# County Department of Public Health

Permit Number MM11802-1

Authorization for Wastewater System Construction (Expires five years from date of issuance of Improvement Permit)

### OPERATION PERMIT

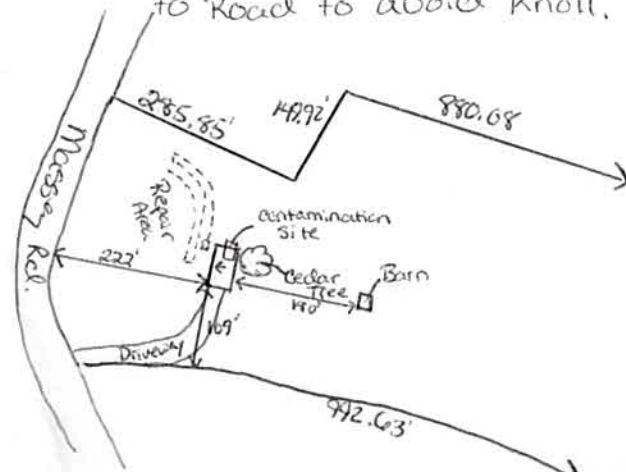
\* Repair = Conventional

\* Move driveway and  
gutters away from septic  
system areas.

\* INSTALL ON CONTOUR\*  
\* LANDSCAPE PROMPTLY\*

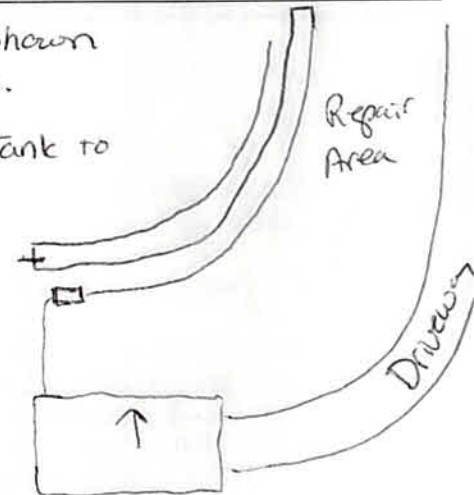
2/4/04 - Driveway moved to left side of property.  
OK to move drainlines 30' closer  
to Road to avoid Knoll.

\*Installed as shown  
with 15' stepdown.

\* 9 1/2" fall from Tank to  
Drainlines.
